PLAN OF PROPOSED IMPROVEMENT

2503 SEIFERTH ROAD

CITY PROJECT NO. 14925  
CONTRACT NO. 9376

REVISION 1: 10/29/2024  
- REVISED SHEETS: U1-U3

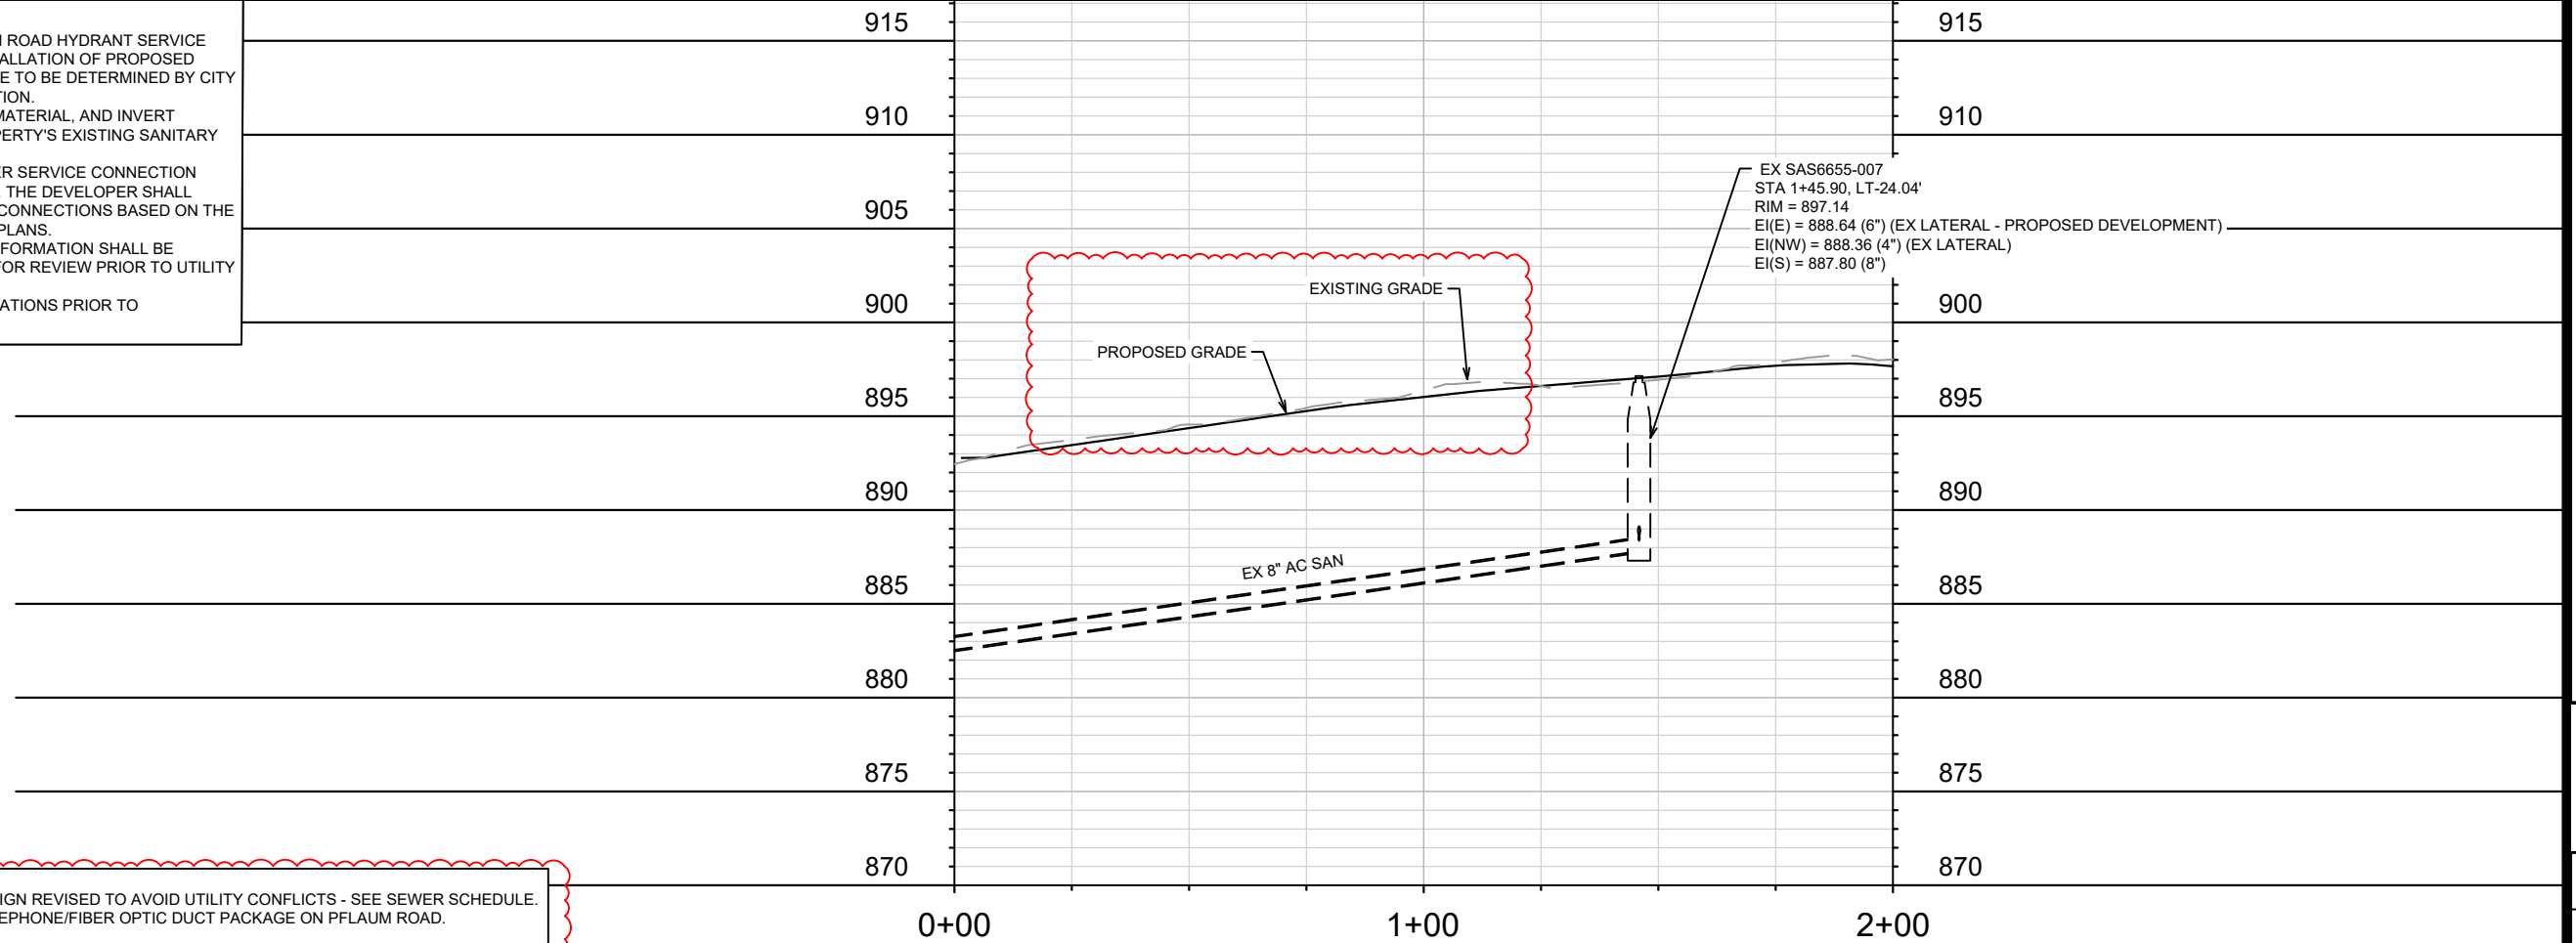
- REVISION #1: 10/25/2024
1. ULO DATA ADDED. STORM SEWER DESIGN REVISED TO AVOID UTILITY CONFLICTS - SEE SEWER SCHEDULE.
  2. ADDED APPROXIMATE LAYOUT OF TELEPHONE/FIBER OPTIC DUCT PACKAGE ON PFLAUM ROAD.
  3. MINOR NOTE ADDITIONS.

14925	MADISON, WI	9376	U-2
14925	2503 SEIFERTH ROAD	U-2	
M:\DESIGN\Projects\14925\CAD\Sewers\14925SWR-PipeNetwork.dwg			
14925			
U-2

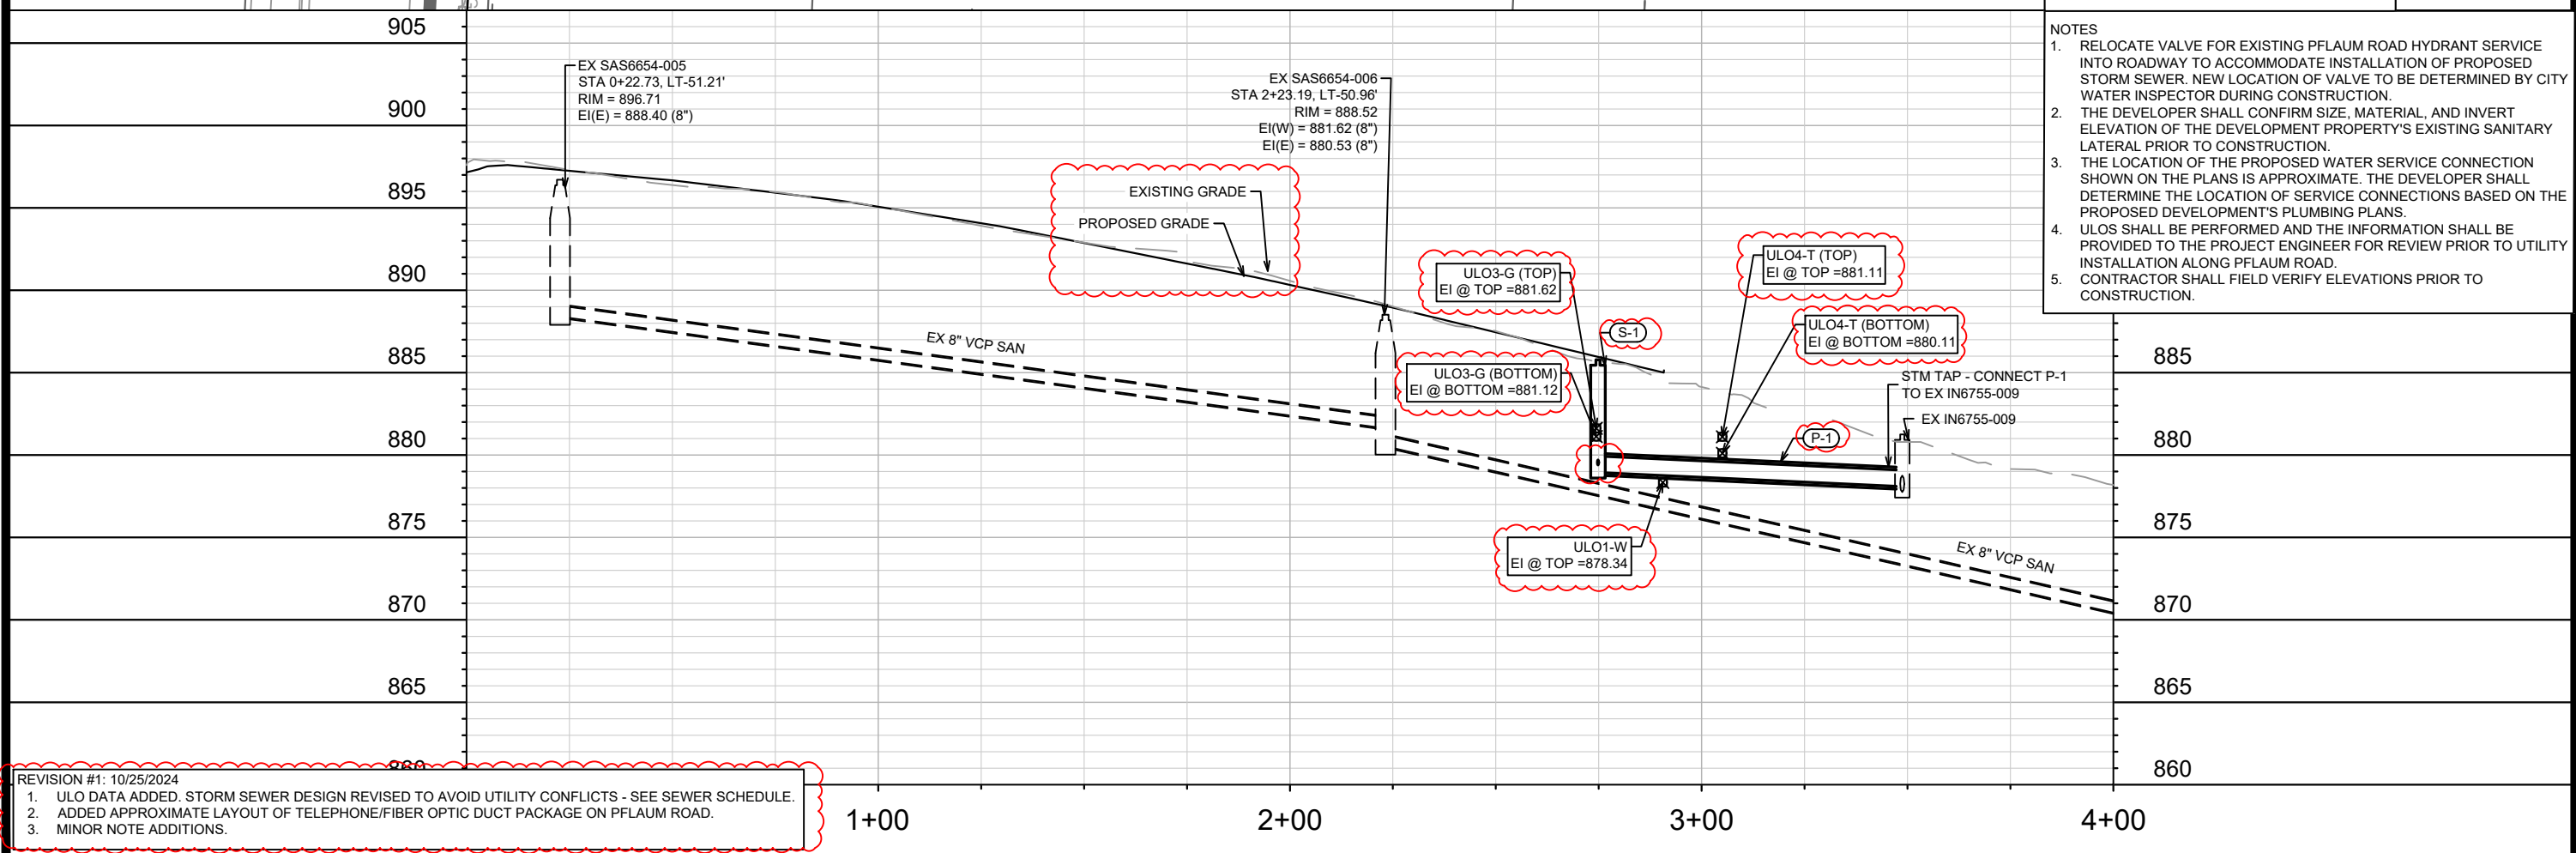
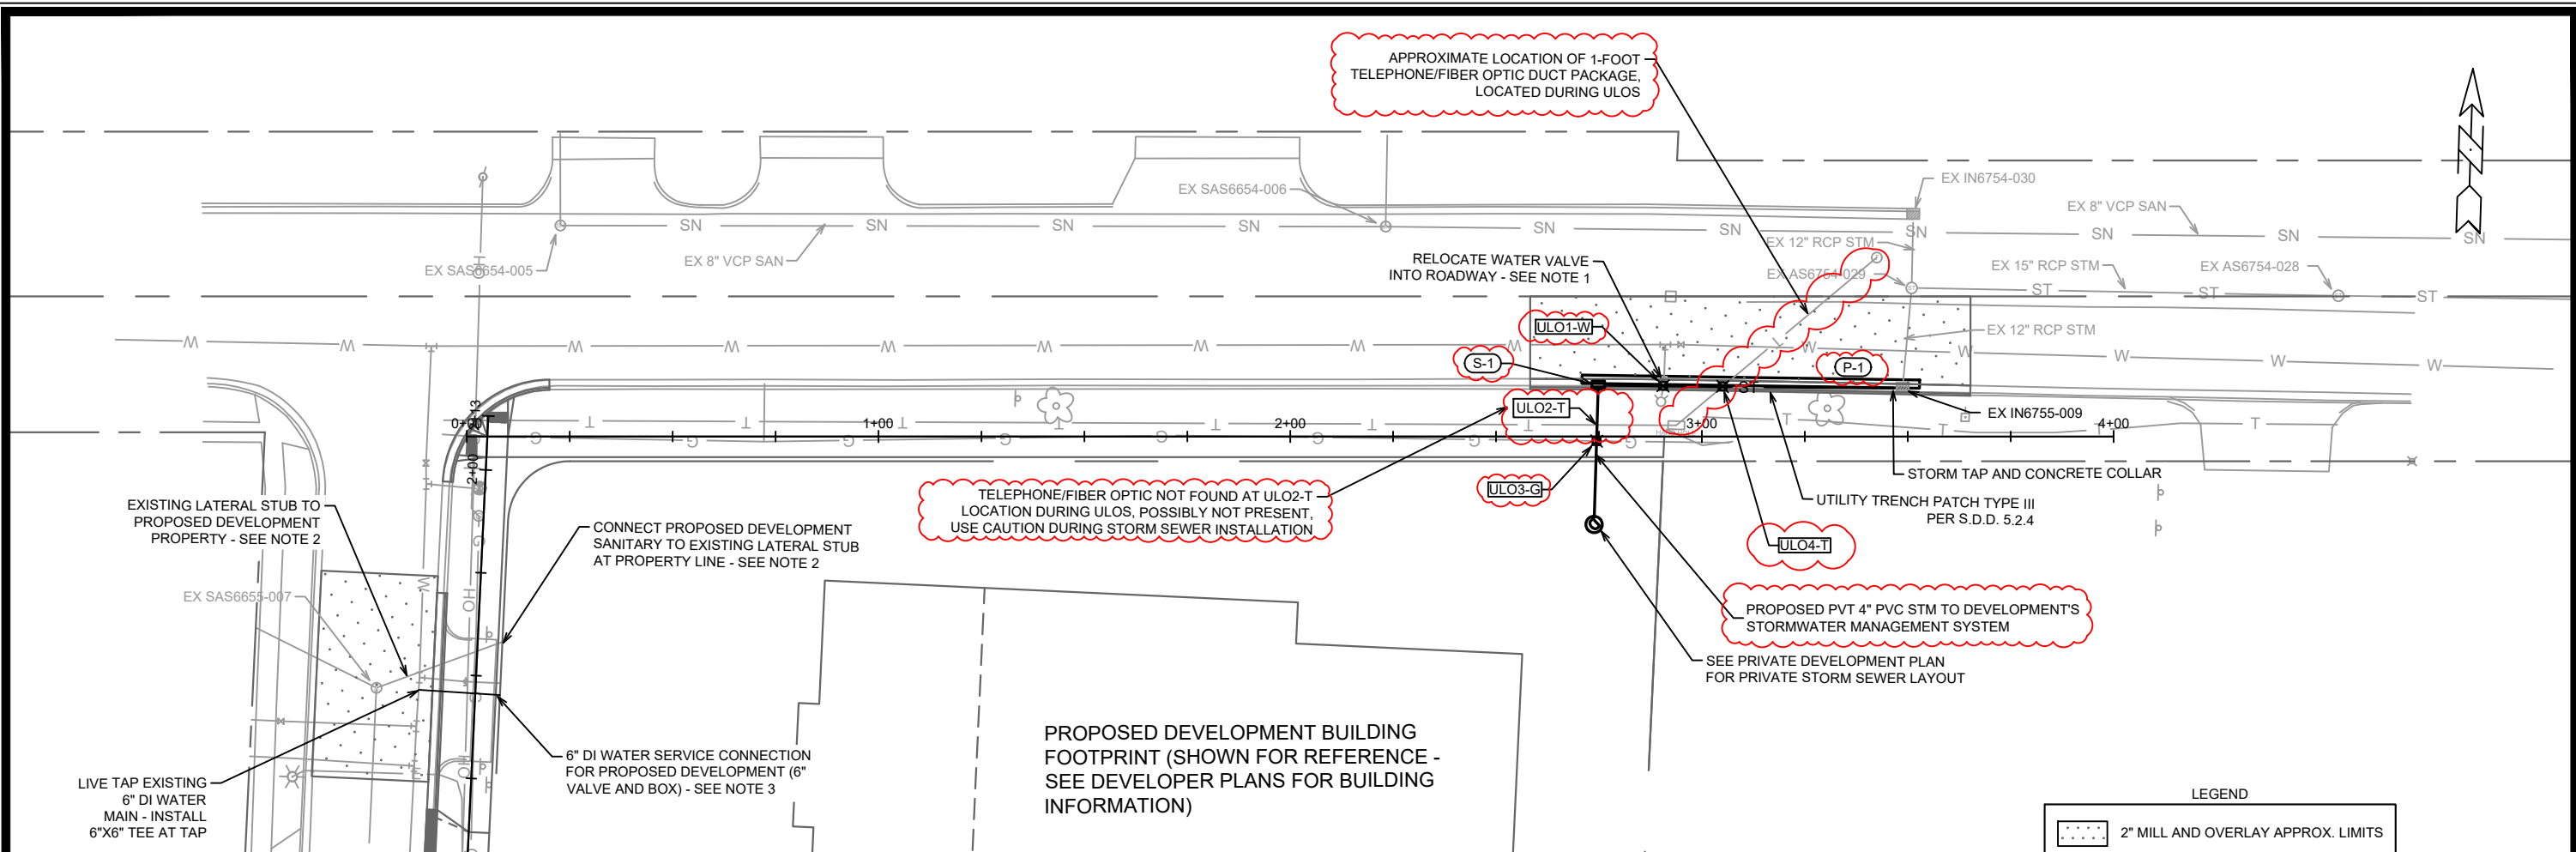
REVISION #1: 10/25/2024  
1. ULO DATA ADDED. STORM SEWER DESIGN REVISED TO AVOID UTILITY CONFLICTS - SEE SEWER SCHEDULE.  
2. ADDED APPROXIMATE LAYOUT OF TELEPHONE/FIBER OPTIC DUCT PACKAGE ON PFLAUM ROAD.  
3. MINOR NOTE ADDITIONS.
